CITY OF MADISON
CITY ENGINEERING DIVISION
DEPARTMENT OF PUBLIC WORKS
PLAN OF PROPOSED IMPROVEMENT
PHEASANT BRANCH GREENWAY ENHANCEMENT

CITY PROJECT NO. 14370

ADDENDUM #2
REVISED THE FOLLOWING:
SHEETS D1-D3
SHEETS EC1-EC4
SHEETS G13, G15, G112
SHEETS P1-P19, P21, P24-27
SHEETS U1-U18, U22
SHEETS E1-E6
SHEET PM1
SHEETS X32A-X34, X45-X48

REVISION 2
SHEET EC1-EC2
SHEETS P9, P13, P14
SHEETS U1, U5, U9, U11, U16, U19, U21
SHEETS X18-X19, X48

14370
EC2

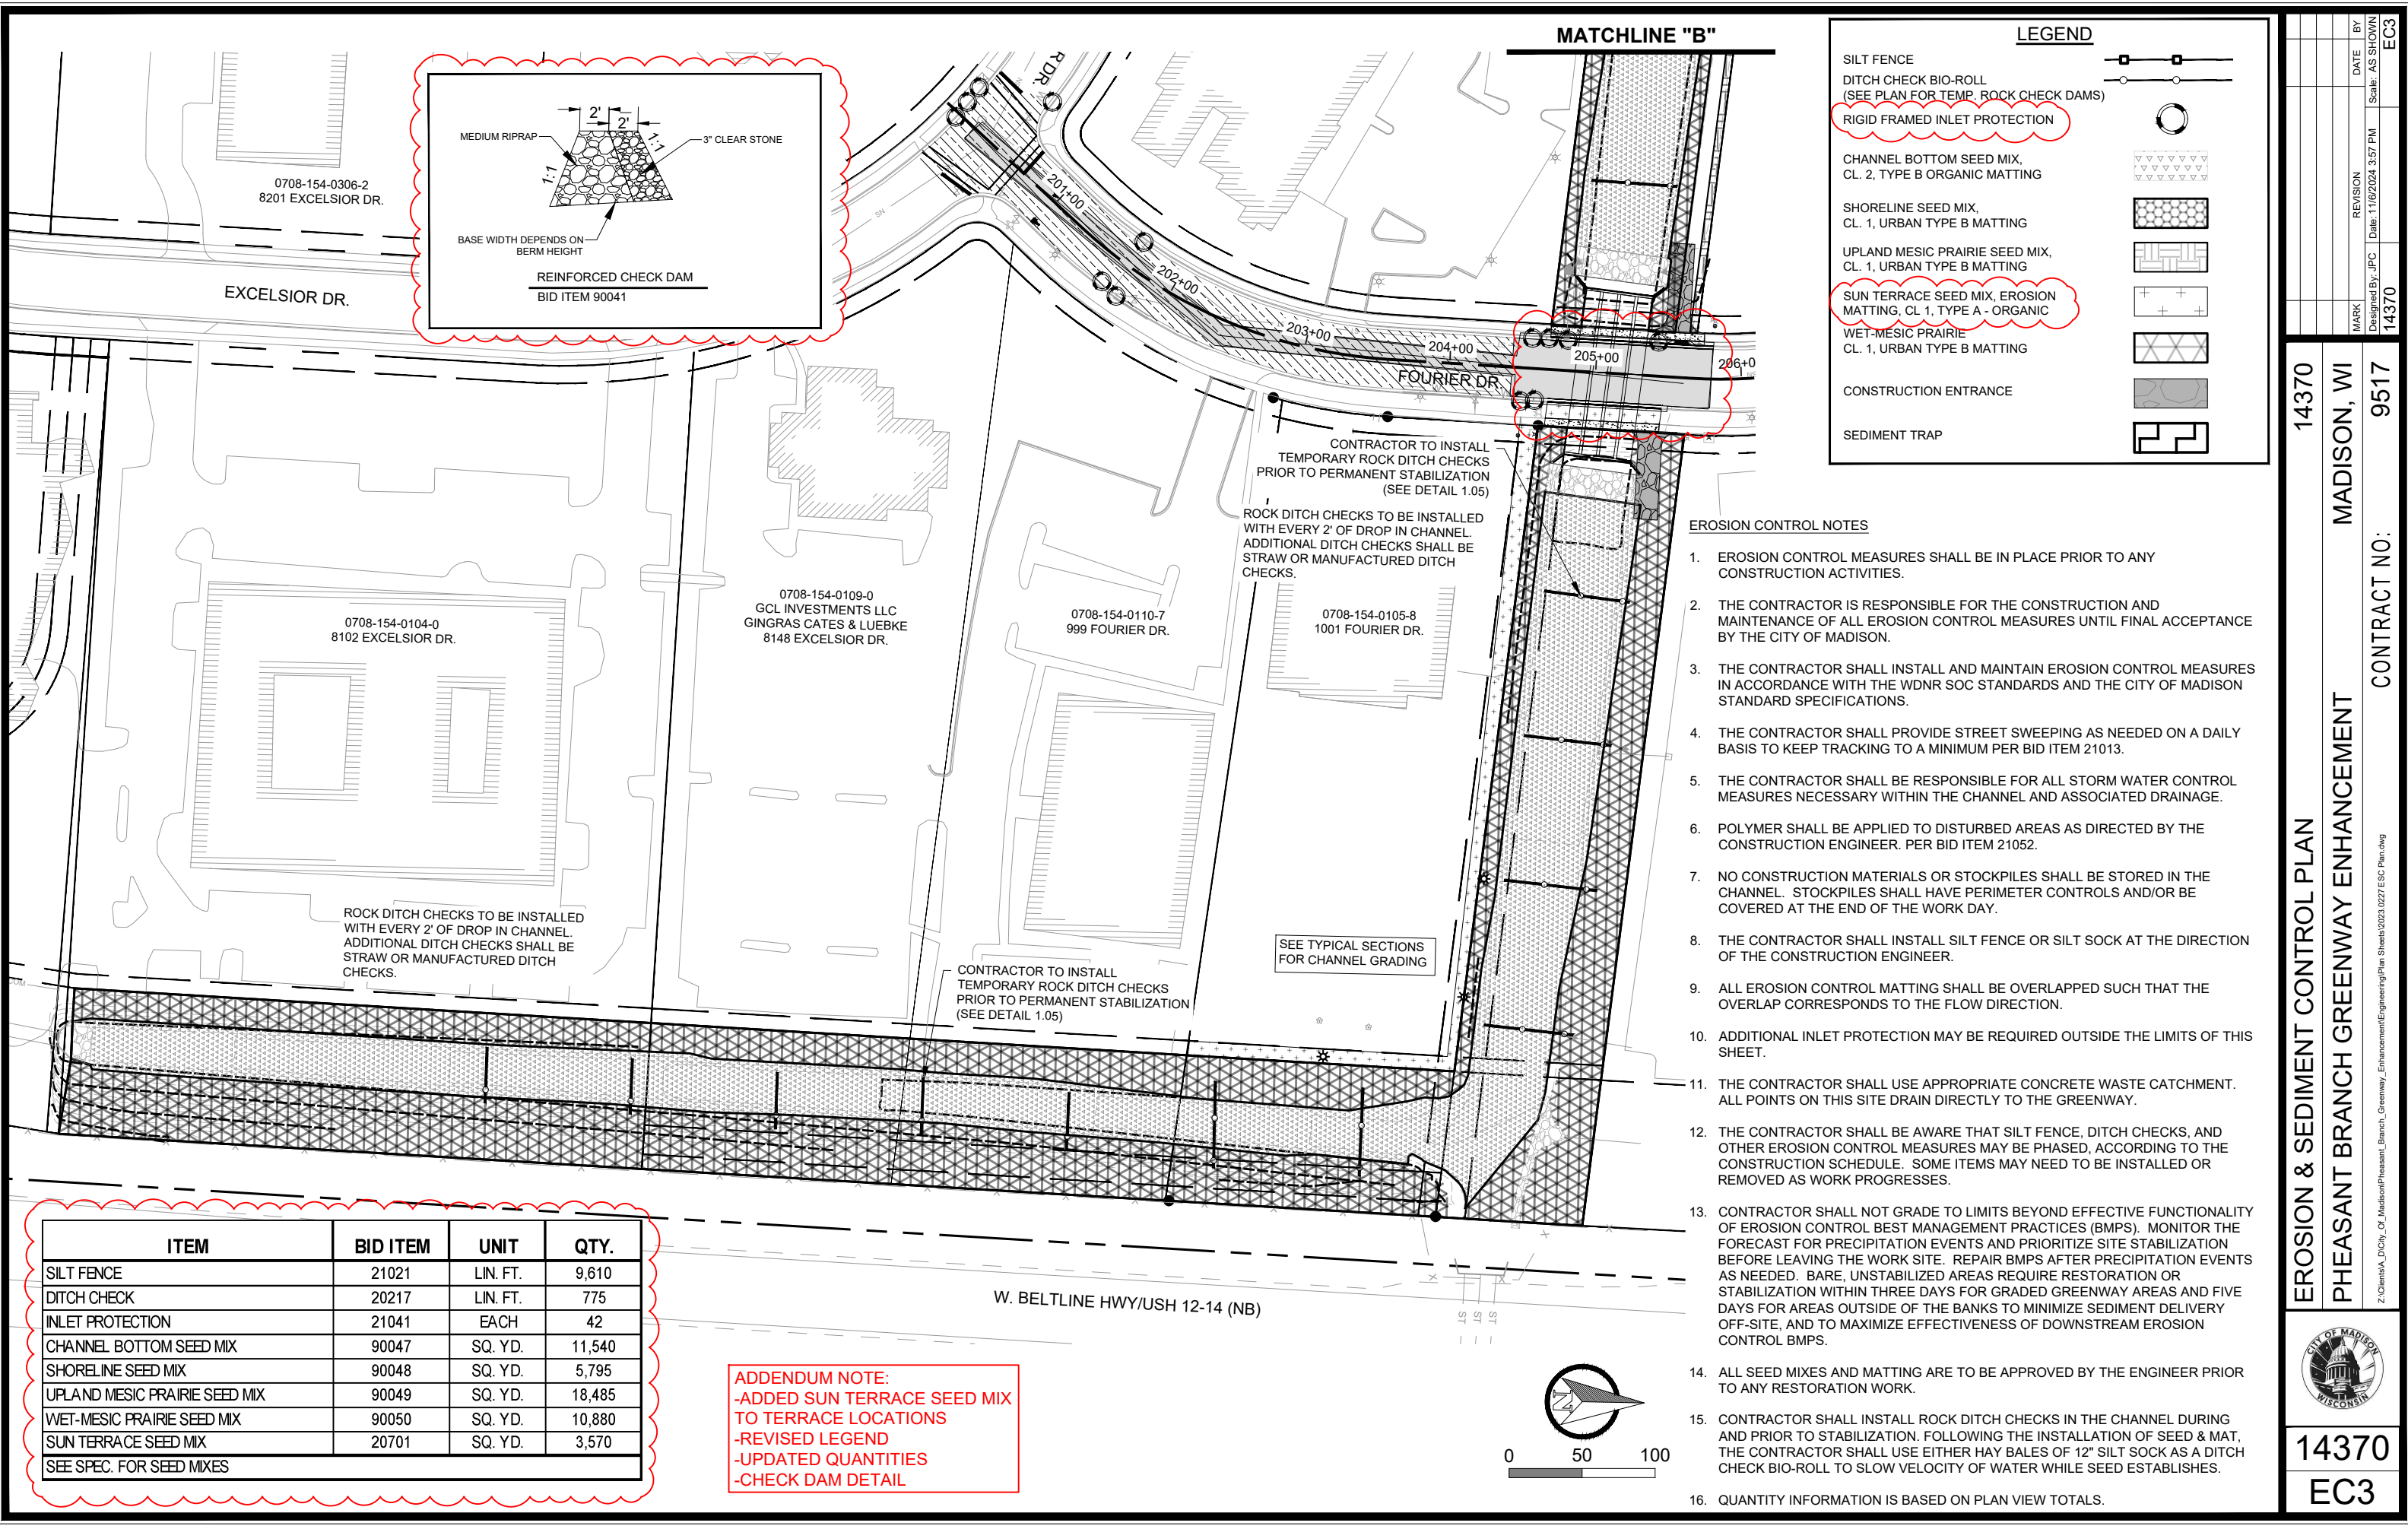
ADDENDUM NOTE:
-ADDED SUN TERRACE SEED MIX TO TERRACE LOCATIONS
-REVISED LEGEND
-UPDATED QUANTITIES
-CHECK DAM DETAIL

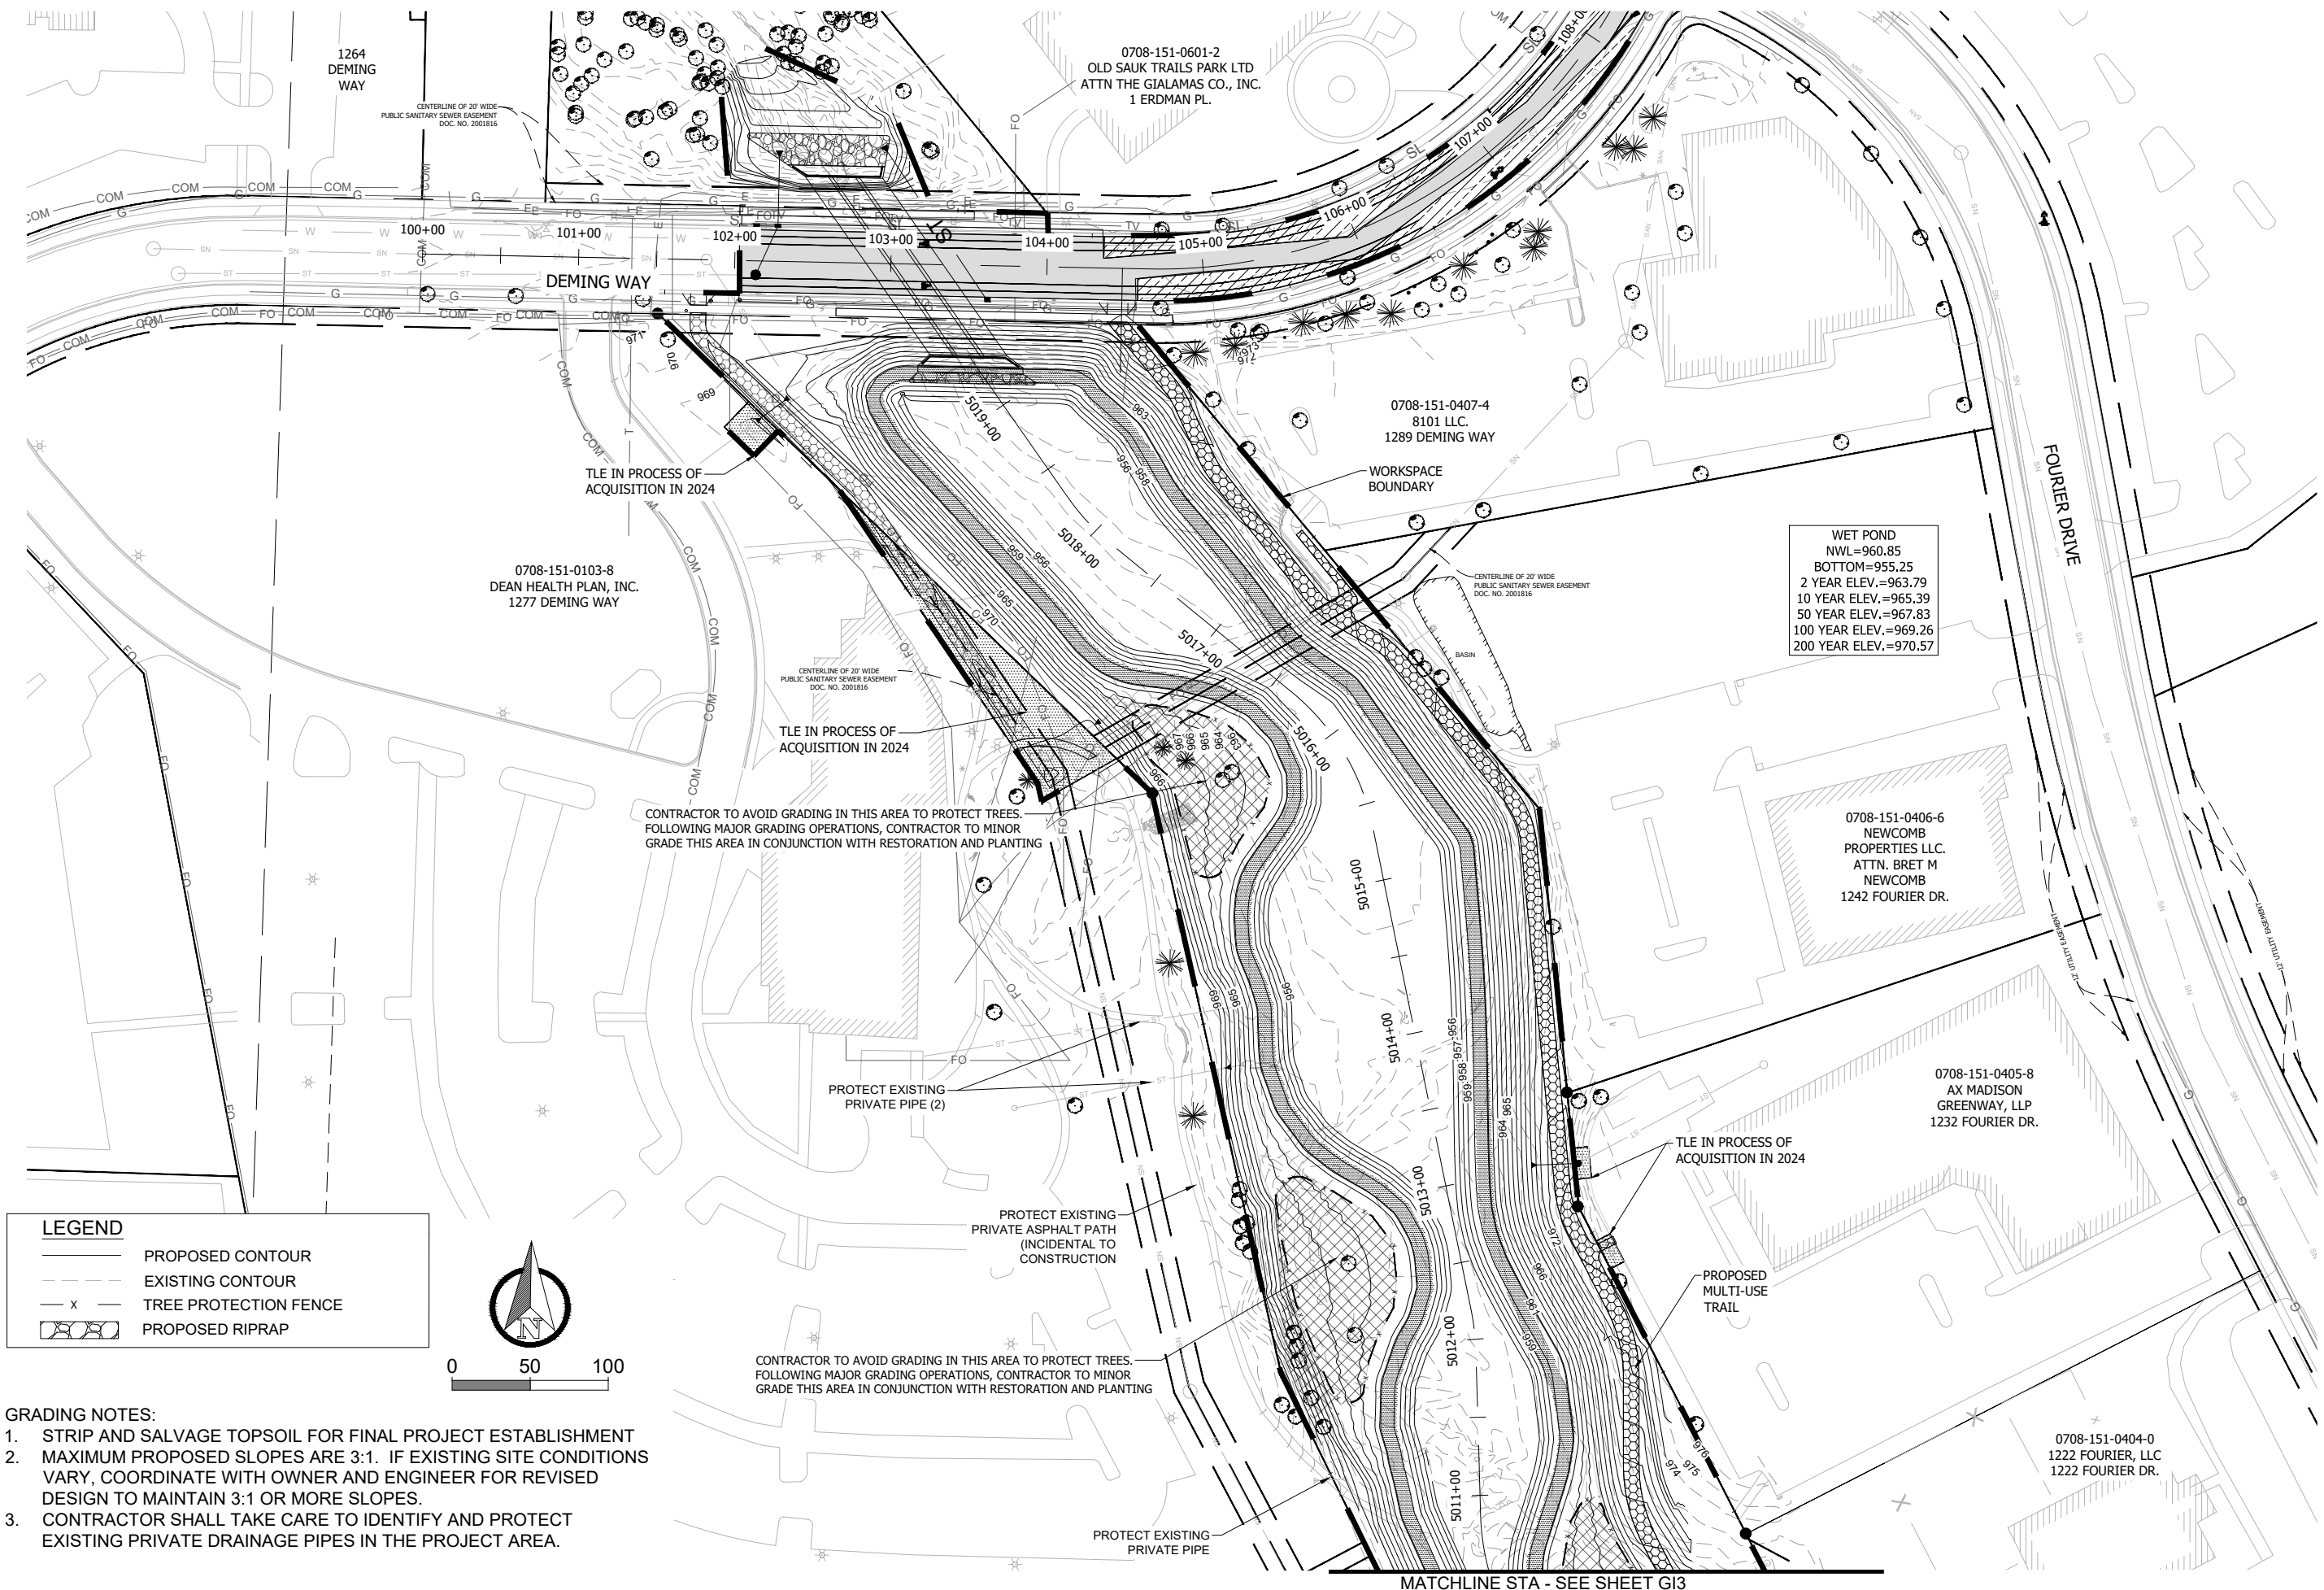
ADDENDUM NOTE:
ADDED PRIVATE UTILITIES

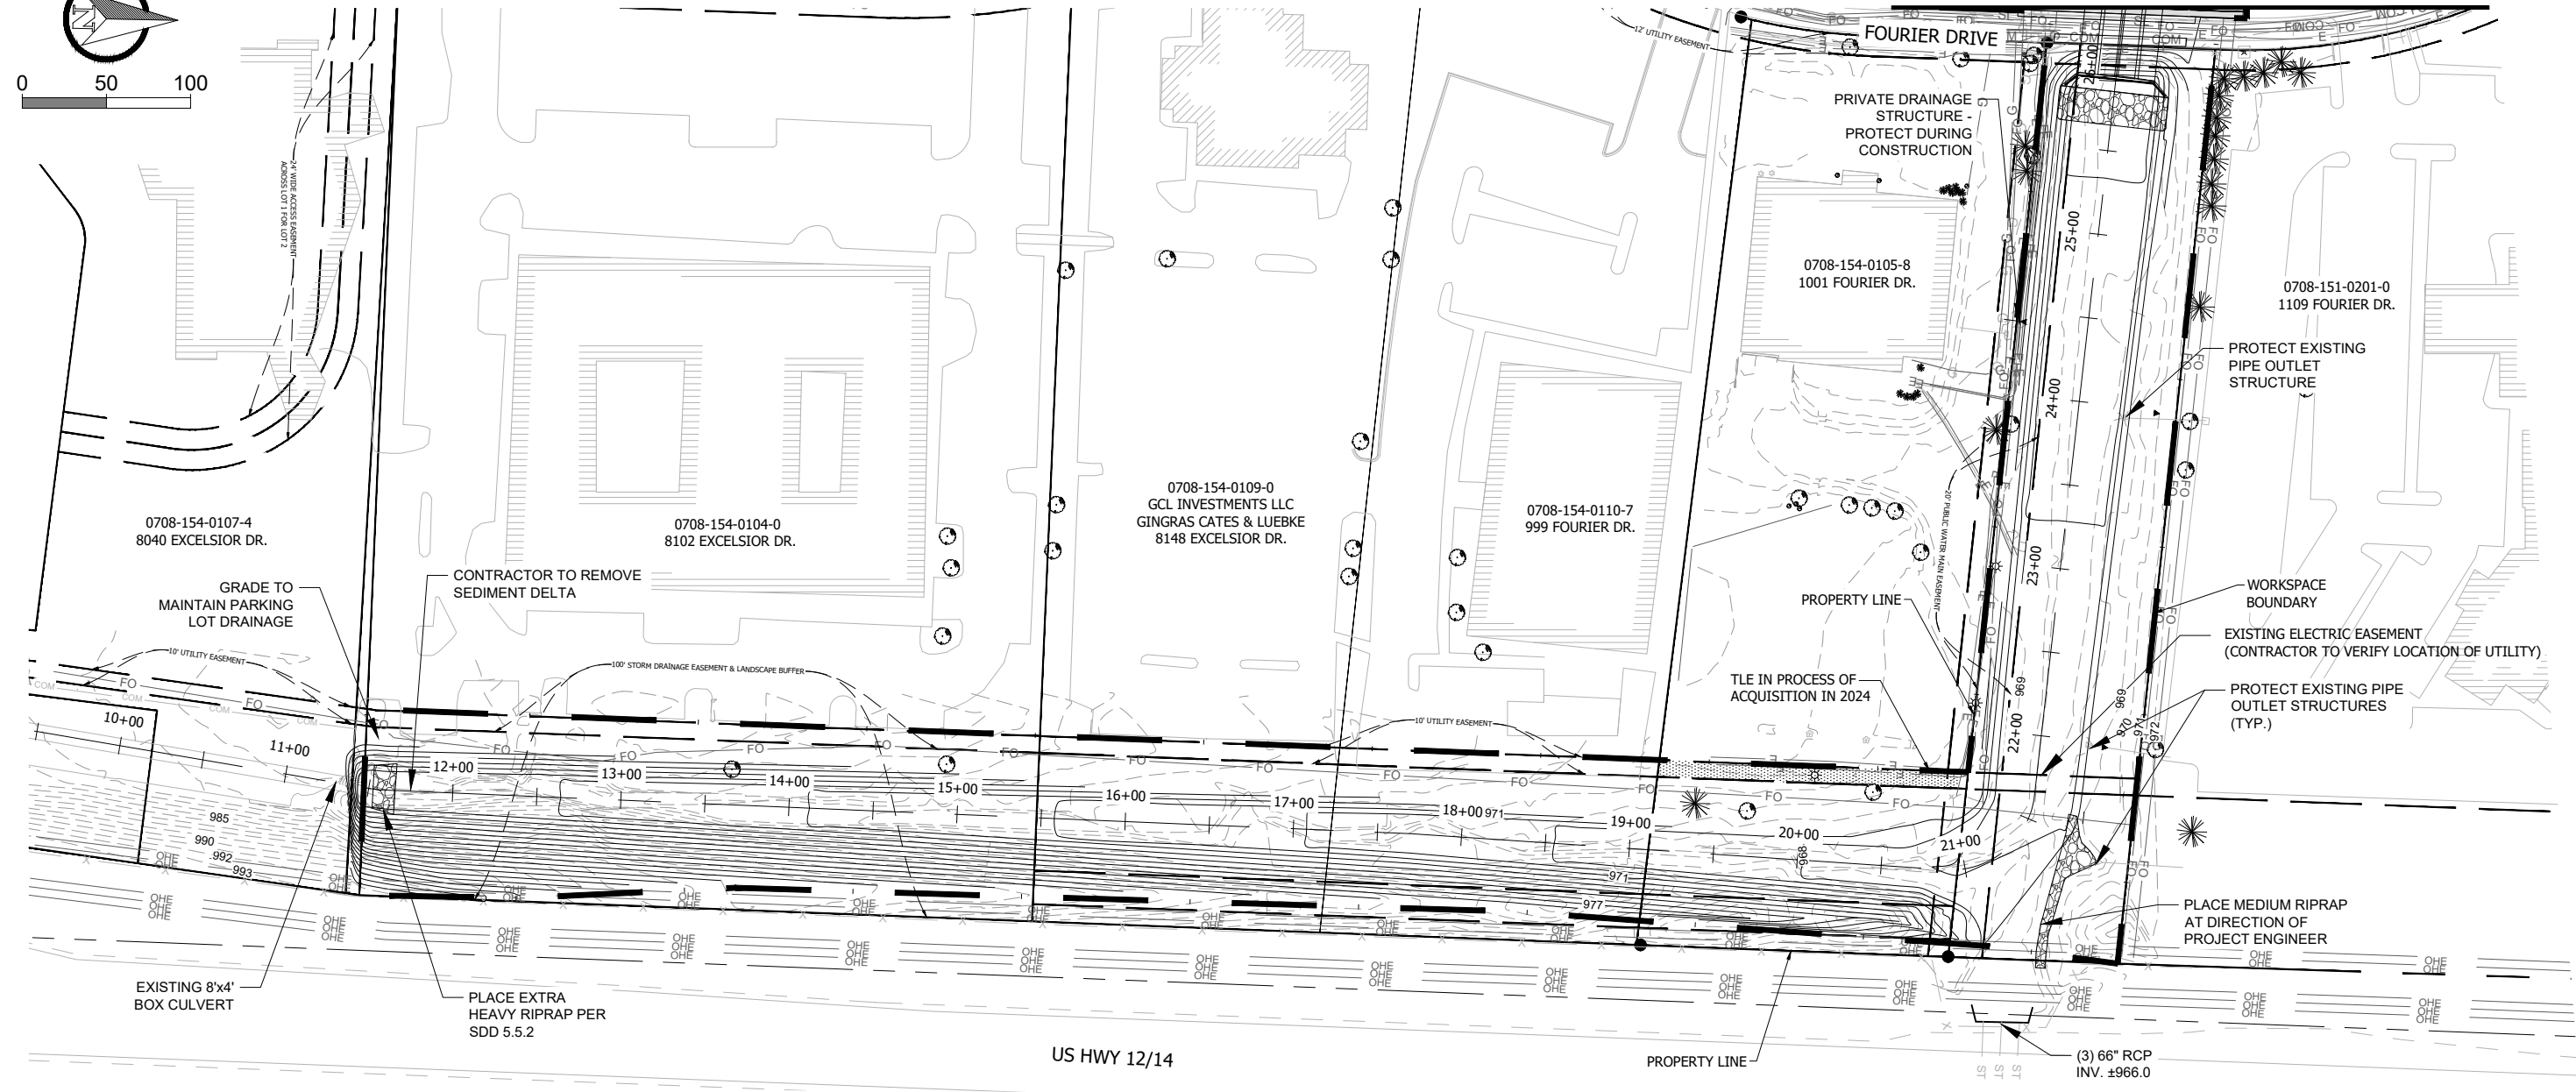
**ADDENDUM NOTE:
REVISED TREE SIZE**
